DIVISION II. RESIDENTIAL CODE

Sec 5-46. International Residential Code – Adopted. The International Residential Code, 2009 Edition and Appendix Chapters G, H and M, as published by the International Code Council, Inc., a copy of which is on file in the office of the City Secretary, as amended by Sec. 5-28, administered and enforced by the office of the Building Official is hereby adopted by reference and designated as the Residential Code of the City as though such code were copied at length in this article.

Sec 5-47. Same – Deletions and Amendments. The residential code adopted in this article is hereby amended and changed in the following respects :

FIGURE R602.6.1
TOP PLATE FRAMING TO ACCOMMODATE PIPING

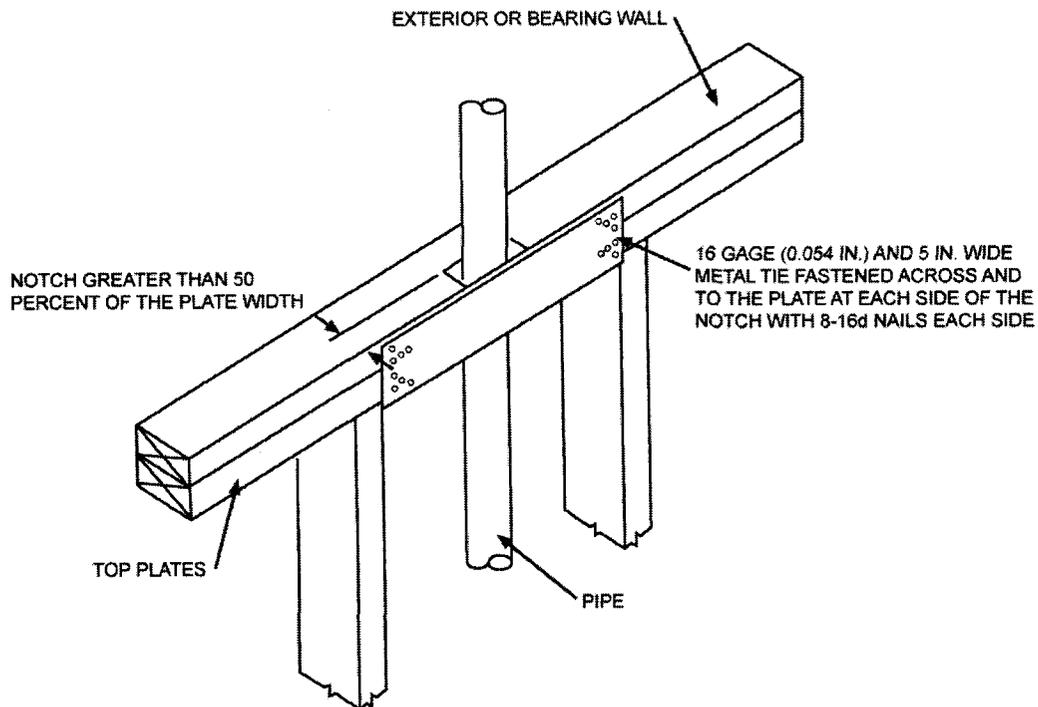
*****Figure R602.6.1; delete the figure and insert the following figure:**

R602.6.1 Drilling and notching of top plate. When piping or ductwork is placed in or partly in an exterior wall or interior load-bearing wall, necessitating cutting, drilling or notching of the top plate by more than 50 percent of its width, a galvanized metal tie not less than 0.054 inch thick (1.37 mm) (16 Ga) and 5 inches (127 mm) wide shall be fastened across and to the plate at each side of the opening with not less than eight 10d (0.148 inch diameter) having a minimum length of 1 ½ inches (38 mm) at each side or equivalent. Fasteners will be offset to prevent splitting of the top plate material. The metal tie must extend a minimum of 6 inches past the opening. See figure R602.6.1.
